Erratum

Figure 2-12. Flow recorded (hourly data) at site 65 (Gordon above Denison), from July 2008 to June 2009, and analysis of non-conforming flows

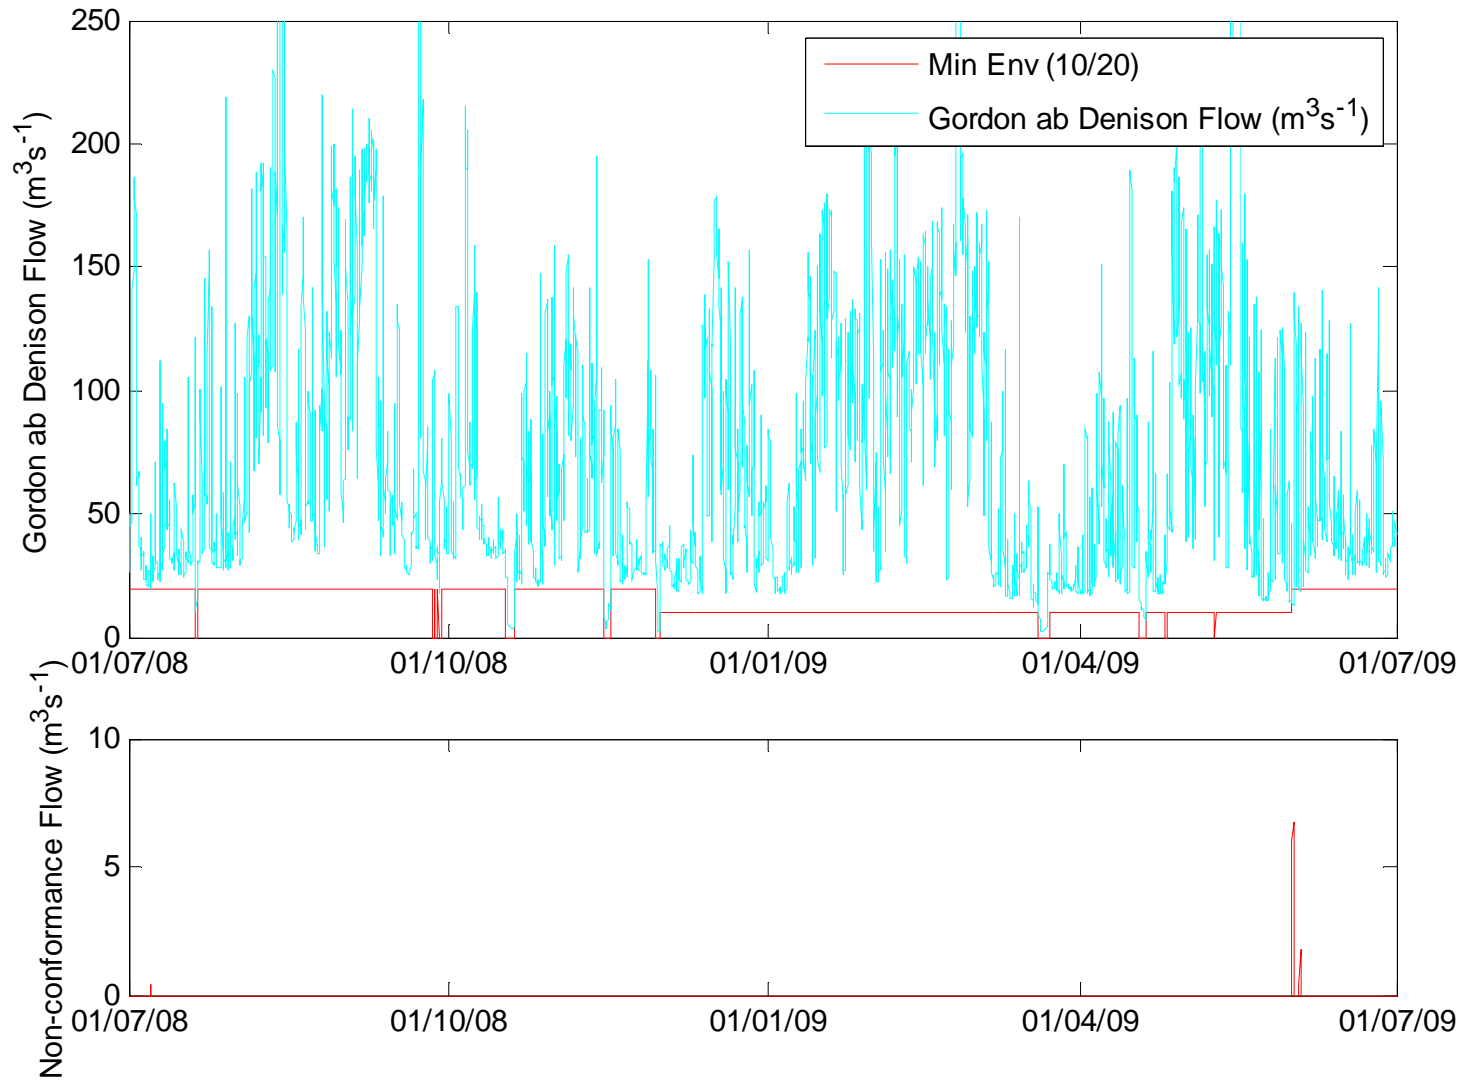
Section 2.5.4.1 Flow, Figure 2-12 on Page 25 should be replaced with the following:

An analysis of hourly flows at site 65 (Figure 2-12 shows that for the winter period (July–November 2008 and June 2009), the minimum flow requirement of $20 \text{ m}^3\text{s}^{-1}$ was satisfied for 99.66 % of the time. The minimum summer (December 2008–May 2009) flow requirement of $10 \text{ m}^3\text{s}^{-1}$ was satisfied for 100 % of the time. Compliance with the environmental flow on an annual basis was 99.83 %. Note that times of shutdown of Gordon Power Station due to maintenance, NEMMCO conformance testing, and/or monitoring have been excluded from the analysis, as per the licence conditions.

Three non-conformances were recorded for a total of 15 hours.
